ENGINEER'S SEAL  DAVID SOULE P.E. #14522	LA MADELEINE		DRAWN BY WCWJ
	GRADING AND DRAINAGE PLAN  <i>Rio Grande Engineering</i> 1606 CENTRAL AVENUE SE SUITE 301 ALBUQUERQUE, NM 87106 (505) 872-0989		DATE 12-12-16 21634-14522-10-25-16
			SHEET # C001
			JOB # 21634

la Madeline
COUNTRY FRENCH CAFÉ
2110 LOUISIANA BLVD. NE
ALBUQUERQUE, NEW MEXICO 87110

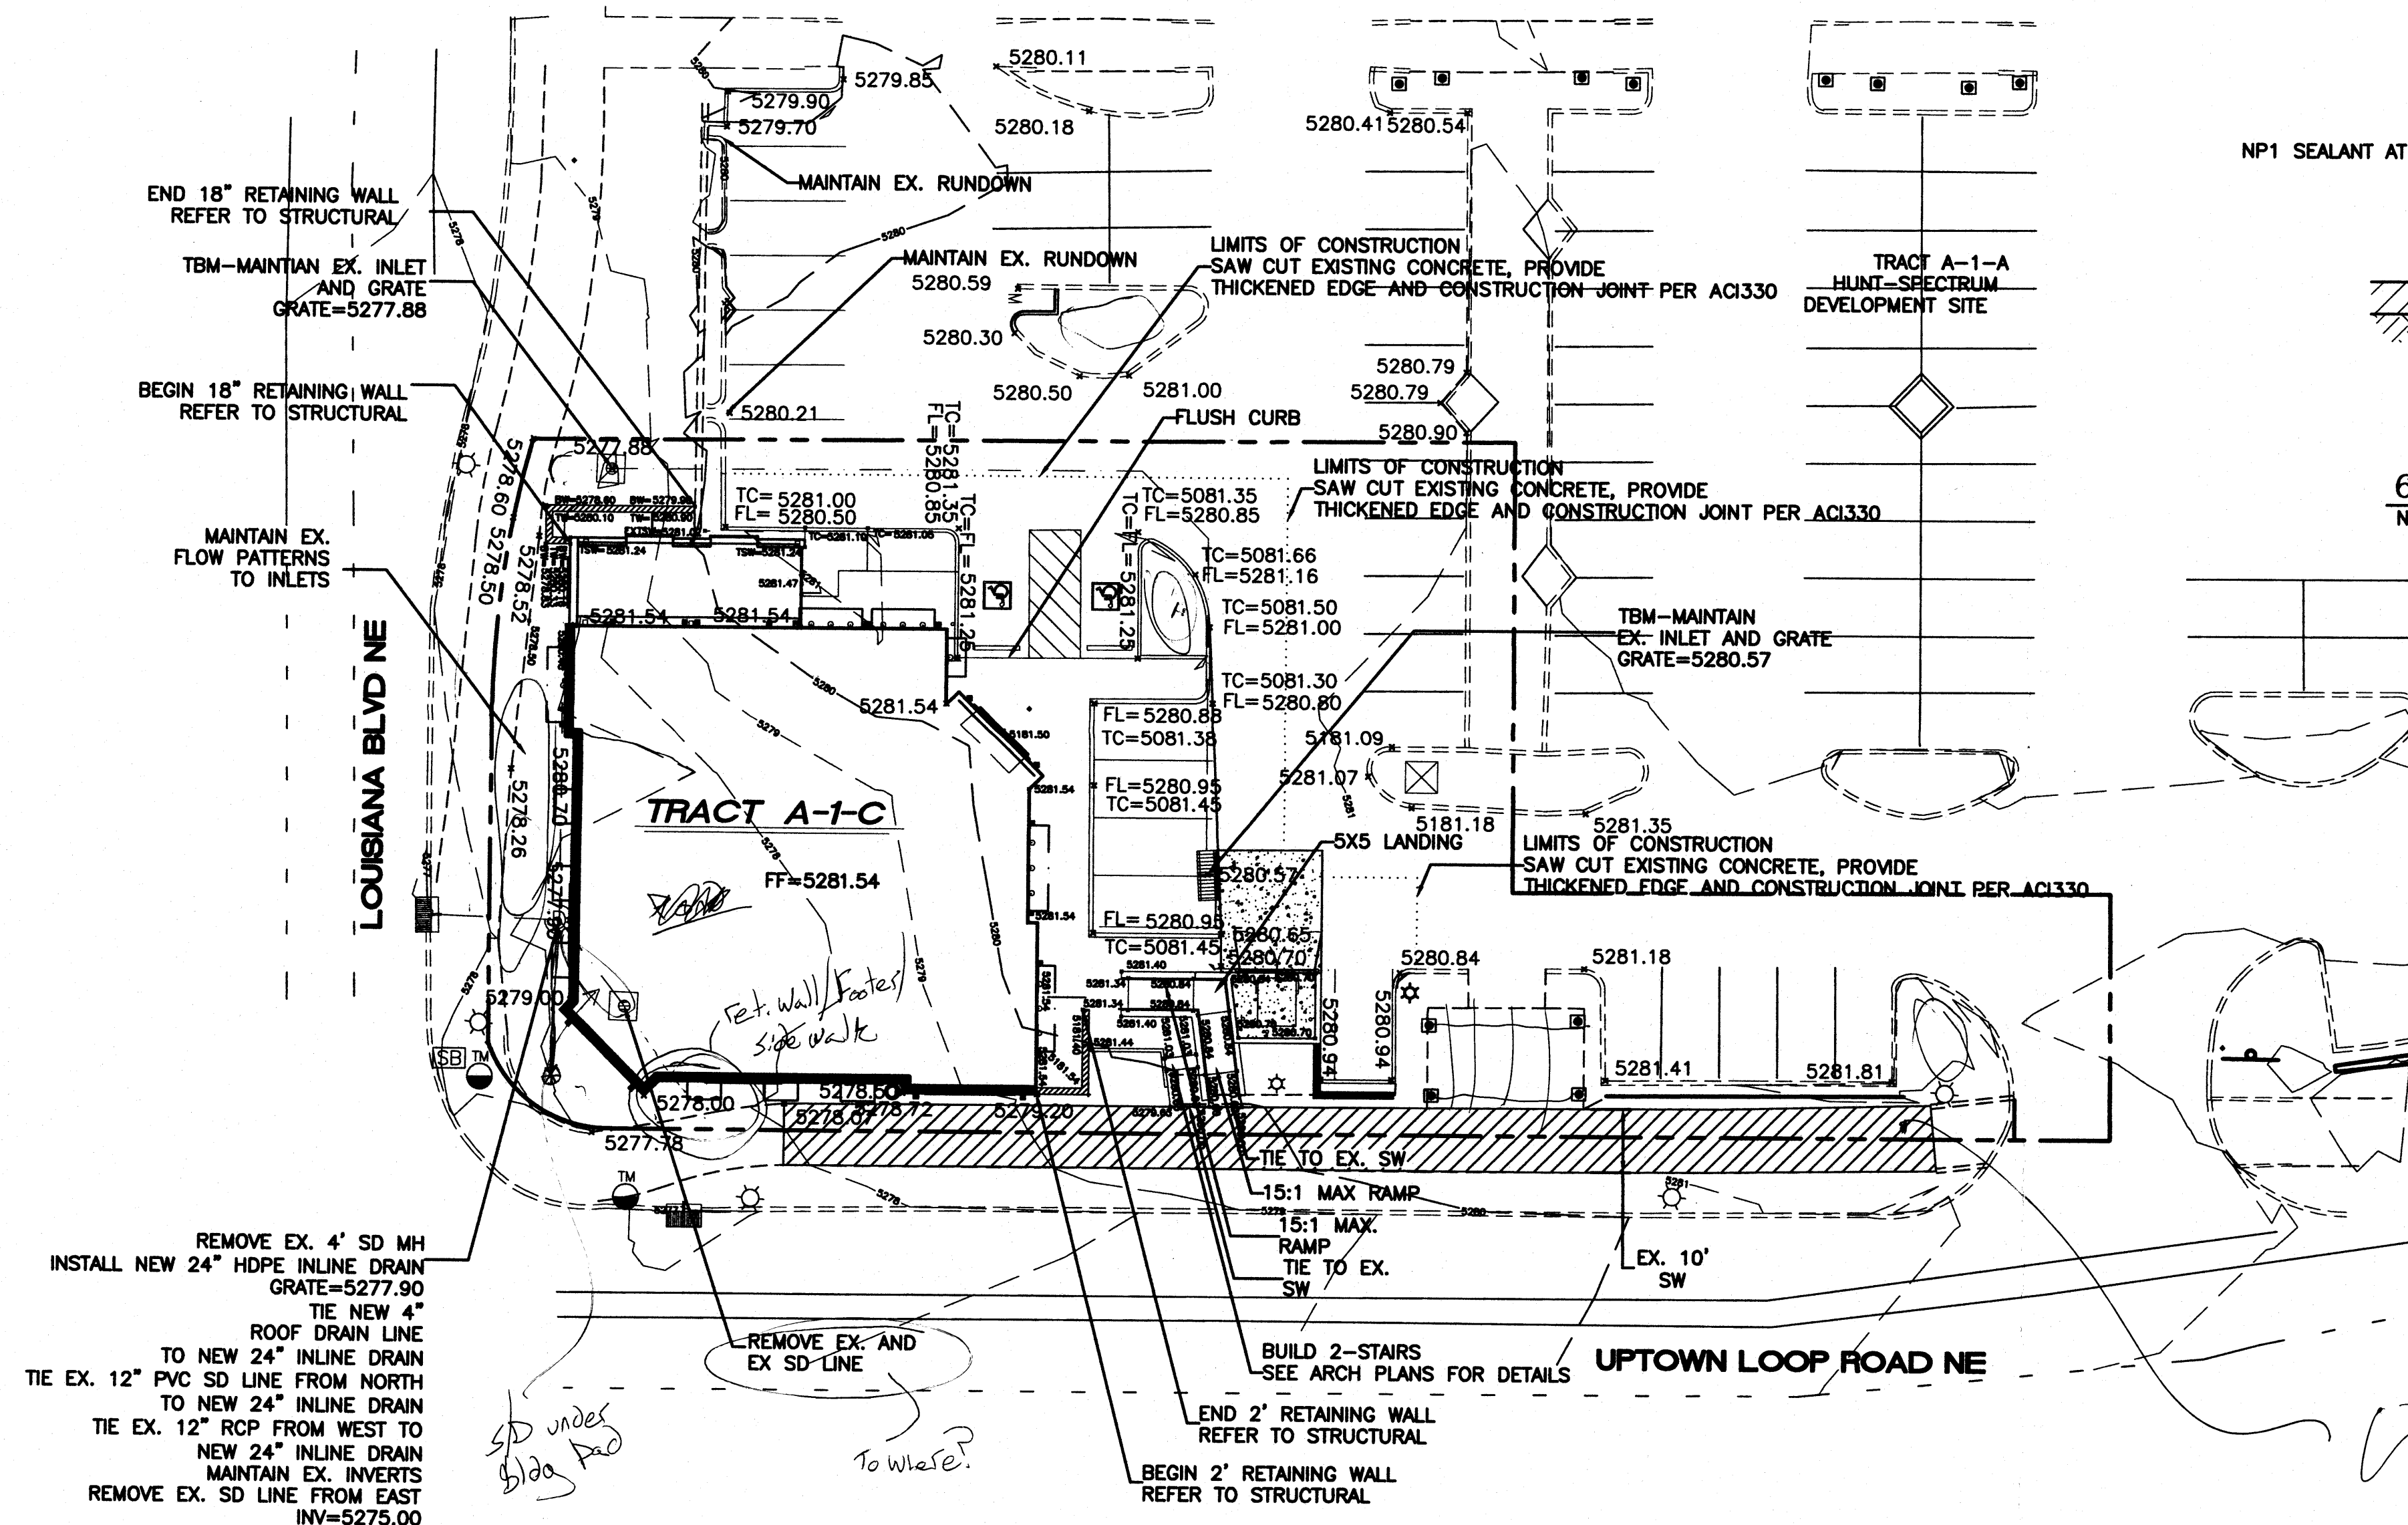
① No 1st Flush detention
② s/d Fem/replace
